Service information

Reference no.: SDA_109733

GC66xx Insulation base repair issue

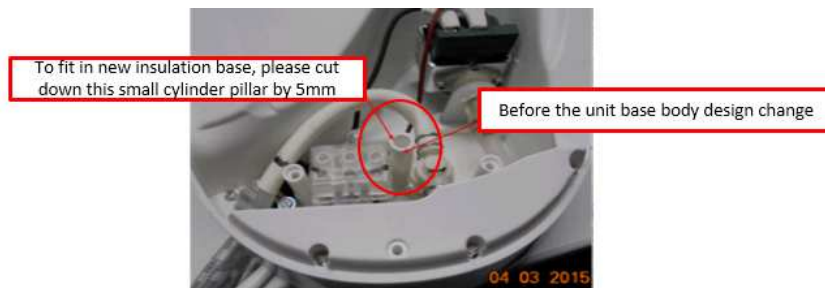
Service center technicians found that the insulation base (pos: 55) is unable to be fit into unit base body (pos:43) during repair.

There was a design change on the unit base body (pos: 43) to exclude the small cylinder pillar (photo as per attached), and Insulation base (pos:55) was subsequently changed to fit into the set in July 2014.

After design change on the unit base body (small cylinder pillar removed) on the left and insulation base after design change on the right.

Service center technicians to cut down the plastic for 5mm, and then the insulation base service part will be able to fit into the unit base body.
